UNITED STATES PATENT AND TRADEMARK OFFICE

10/594,919

Office Action Summary	Application No. 10/594,919	Applicant(s) MORI ET AL.	
	Examiner KAMI A. BOSWORTH	Art Unit 4177

DETAILED ACTION

Fig. A

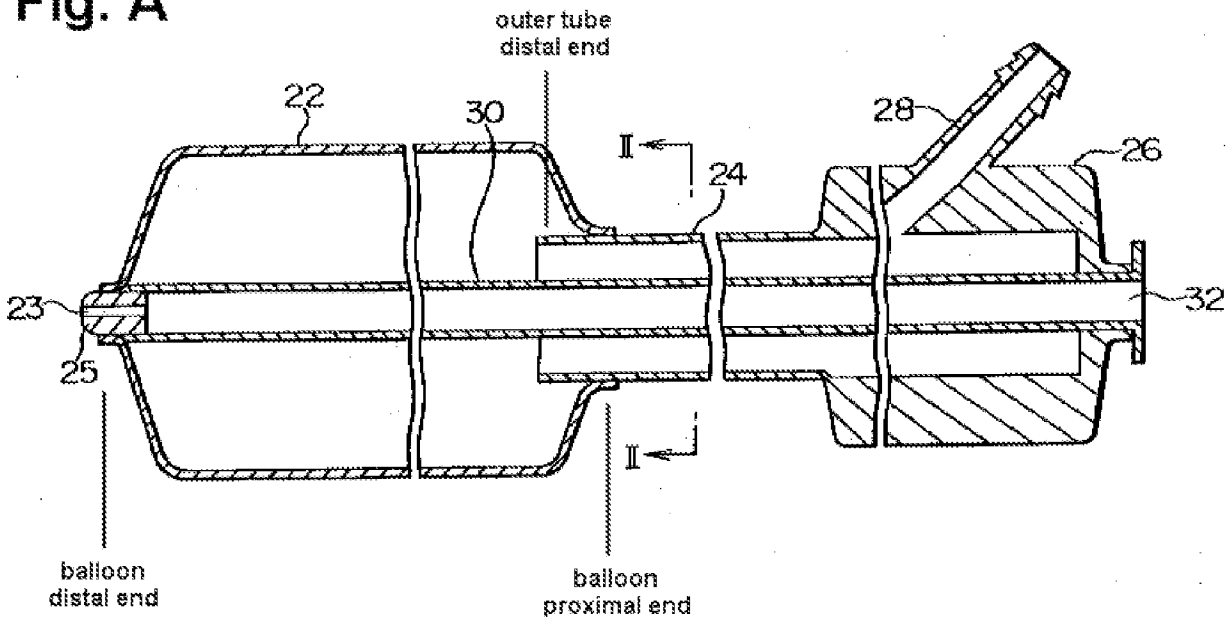
14. Claim 1 is rejected under 35 U.S.C. 102(b) as anticipated by or, in the alternative, under 35 U.S.C. 103(a) as obvious over Miyata et al. (US Pat 5,711,754).

15. Re claim 1, Miyata et al. disclose an intra-aortic balloon catheter 20 (Fig 1) comprising: a balloon part 22 (Fig 1) adapted to be inserted inside the aorta and inflating and deflating to assist the heart function (Col 2, Line 66 - Col 3, Line 1), an outer tube 24 (Fig 1) with a distal end (seen in Fig A below) connected to a proximal end (seen in Fig A below) of said balloon part (Col 4, Lines 66-67) to introduce and guide out pressurized fluid inside of said balloon part (Col 4 Line 67 – Col 5, Line 3), and an inner tube 30 (Fig 1) to which a distal end (seen in Fig A below) of said balloon part is connected (Col 4, Lines 53-55) and extending through the insides of said balloon part and said outer tube in the axial direction (Col 4, Lines 55-57) and wherein said inner tube is fused or adhered with the inside wall of said outer tube (Col 5, Lines 36-39), and an engagement means (adhesion; Col 5, Lines 36-39) engages said inner tube with the inside wall of said outer tube at the distal end of said outer tube. Miyata et al. does not explicitly disclose that the inner tube is fused or adhered with the inside wall of said outer tube over a length of 50% or greater of the total length from the distal end of the outer tube; however, as the inner tube and outer tube are affixed to one another by integral formation (Col 5, Lines 36-39), the tubes are inherently adhered over their entire length. In the alternative, it has been held that where the general conditions of a claim are disclosed in the prior art, discovering the optimum or workable ranges involves only routine skill in the art. *In re Aller*, 105 USPQ 233. Therefore, it would have been obvious to one having ordinary skill in the art at the time the invention was made to affix the inner tube and the outer tube to one another over a length of 50% or greater of the total length of the outer tube for the purpose of ensuring a lasting affixation between the
